STATE OF HAWAII
DEPARTMENT OF LAND AND NATURAL RESOURCES
COMMISSION ON WATER RESOURCE MANAGEMENT
P.O. BOX 621
HONOLULU, HAWAII 96809

STAFF SUBMITTAL

University of Hawaii / U.S. Army Garrison Hawaii
REQUEST FOR WELL CONSTRUCTION VARIANCE
PTA Test Well 2 (Well No. 4738-001)
TMK (3) 6-7-001:041, Island of Hawaii

EXHIBIT 2 – PROPOSED WELL SECTION

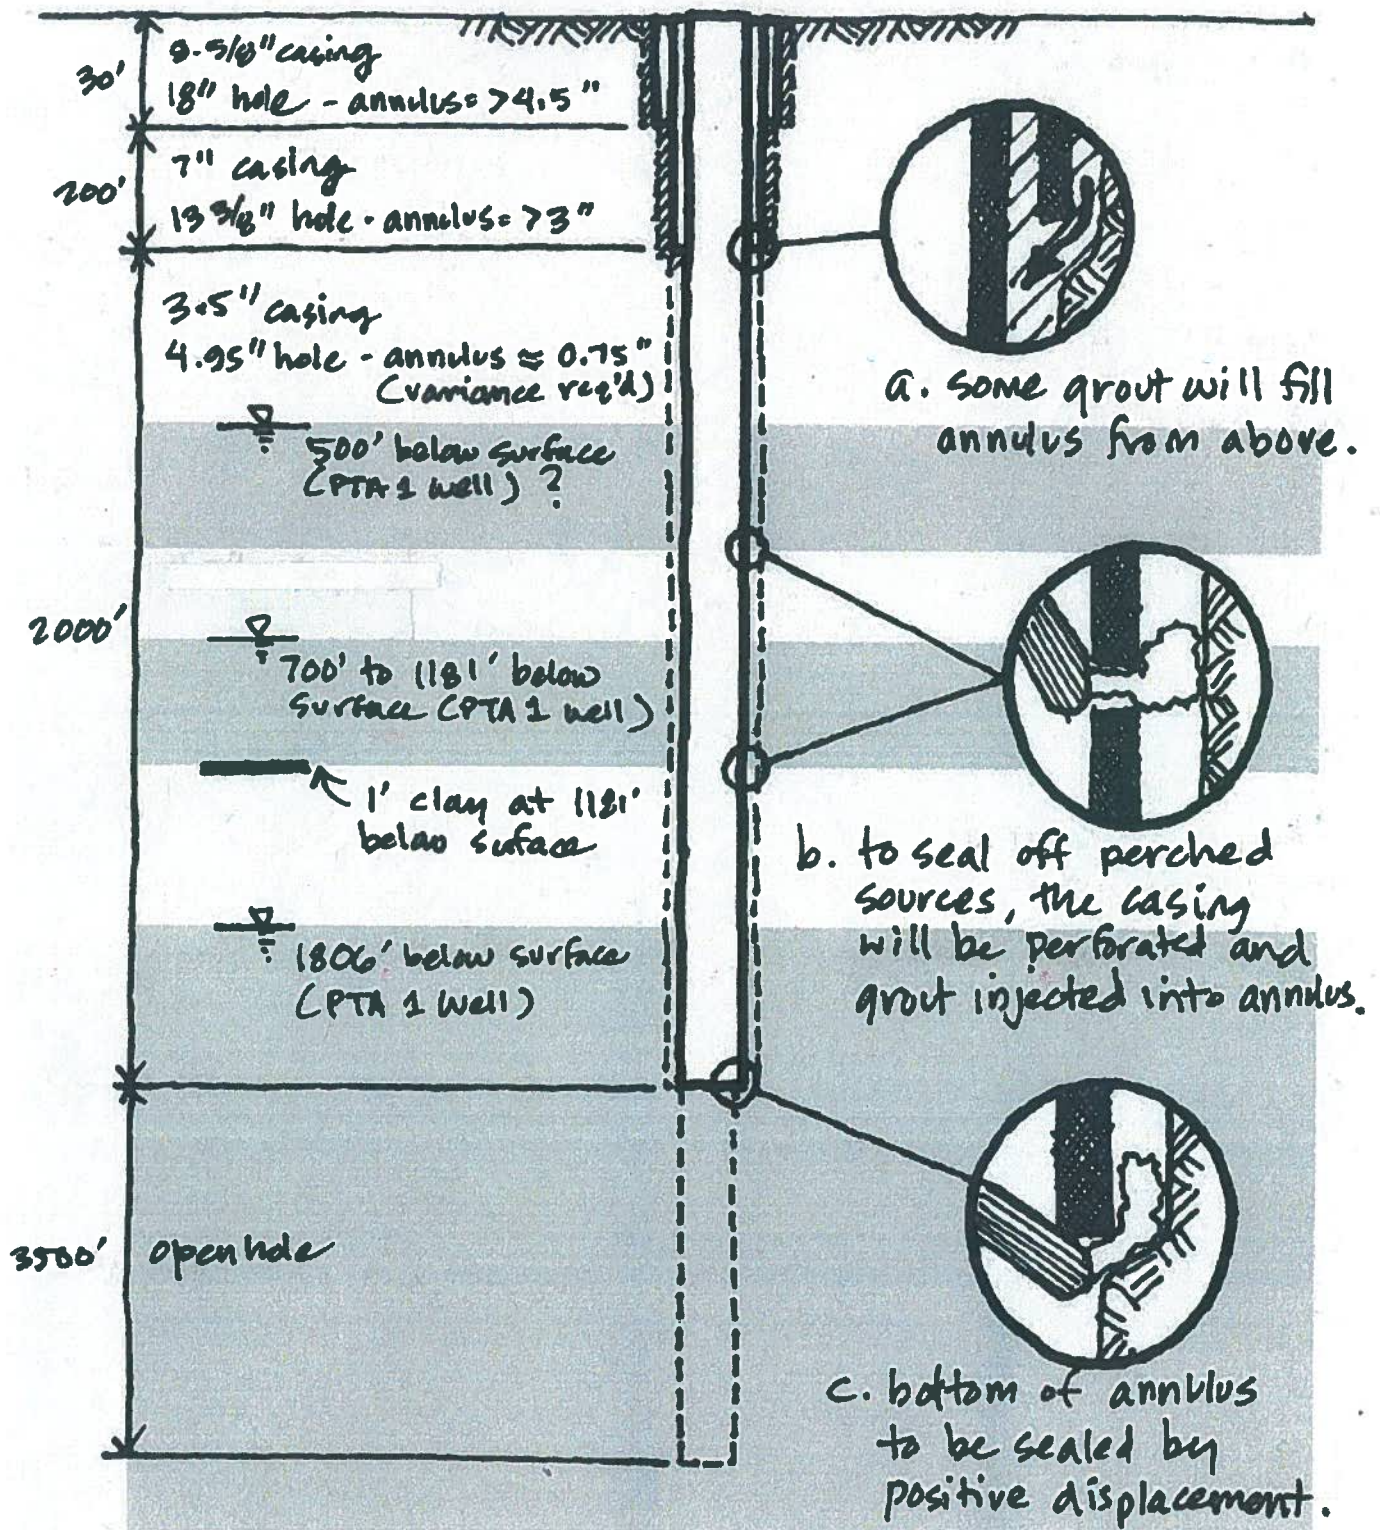
An approved variance would allow only a 230' sanitary seal and a 0.75" annular space in portions of the well bore below 230' depths. The concern with a reduced sanitary sealing depth and annular space is that grout may not fully fill the annular space to protect the aquifer(s) from contamination and aquifer cross-connection.

The construction of this well is unconventional. Dr. Thomas intends to drill the hole via continuous coring, rather than a conventional rotary drill rig. Coring is a drilling method that maintains the original structure of the rock for extraction to get an accurate well profile of the underground geology. It is more time consuming, expensive, and requires specialized equipment to do. The workers employed to do the work were the previous owners of the specialized rig and are licensed in Minnesota & Canada. The coring rig used doesn't allow borehole sizes to the proposed required depths while achieving the required 1.5" annular space (see Exhibit 2).

It is difficult to accurately predict where perched aquifers might be found. According to earlier geophysical studies by Dr. Thomas & Herbert Pierce (USGS Open File Report 2009-1135) there was no compelling evidence of perched ground water above 4000-5000 ft. mean sea-level (msl). However, at least one (possibly two) perched aquifers were encountered during the drilling of PTA Test Well 1. For illustrative purposes the conditions found in the previously drilled well can provide a basis for the proposed variance conditions that may be encountered at PTA Test Well 2 (see Exhibit 2 for the proposed well section).

- a) Some grout that is used to fill the space between the 7" casing and the 4.5" casing will fill some of upper annulus, providing an annular seal depth greater than the 230'.
- b) After placement of the casing, the perched saturated zones can be isolated by perforating the casing and pumping grout into the annulus from inside the casing.
- c) The bottom of the 4.5" casing annular space can be grouted by positive displacement.

Although the design of this well will not conform to the HWCPIIS 2004 requirement for the 1.5" minimum annular space, and as a result depth of grouting will be inadequate, staff feels that the above provisions will minimize the potential for contamination and/or aquifer cross-connections. Staff requests to be given adequate notice in order to be present during these various grouting events to verify the outcome of these proposed efforts. This test hole can be abandoned and sealed should the proposed sealing efforts prove difficult or uncertain.

Staff recommends the Commission approve the variance of HWCPIIS 2.6(c) and (d), subject to the following conditions:

- a) The 9 5/8" casing and the 7" casing shall be grouted without variance, ensuring the first 230' are adequately grouted.

- b) Perched aquifer(s) encountered shall seal the annulus by perforating the casing below the bottom of the perched aquifer and grouting the annulus under positive displacement.
- c) The bottom of the solid casing shall be sealed using positive displacement.
- d) The applicant shall give Commission staff a two week notice prior to any grouting activities, to allow staff to observe grout placement.
- e) If the applicant fails to achieve the goals of proper sanitary and annular sealing through these variances by April 29, 2017, the applicant shall apply for a well abandonment permit and seal the well.
